UNITED STATES PATENT AND TRADEMARK OFFICE

10/531,110

Stephan Bolz

DETAILED ACTION

Fig 2

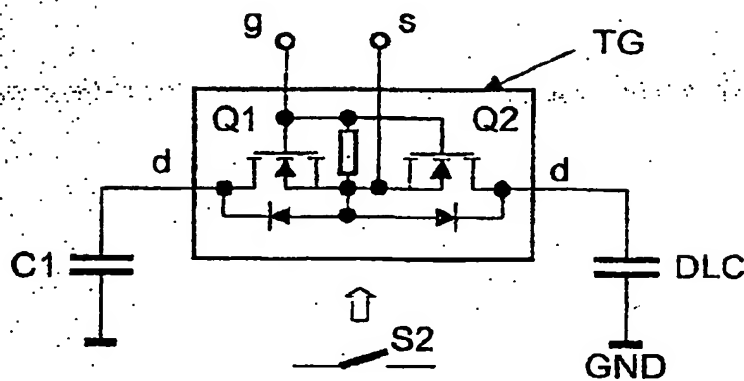
Object. Rectifier K1 is not shown.

Fig 4

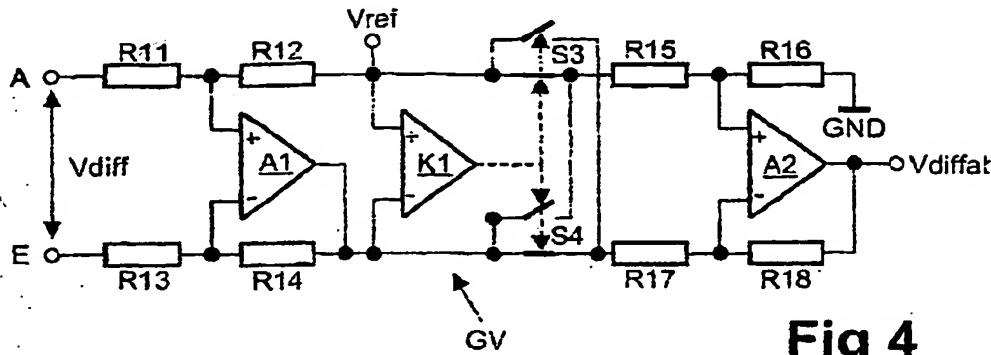
Abs. value

Fig 5

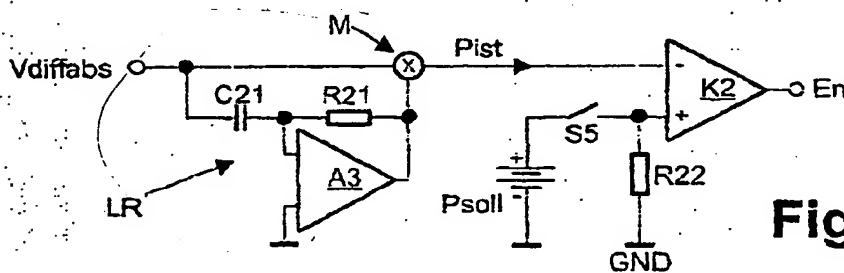
calculate
pwr of
switch
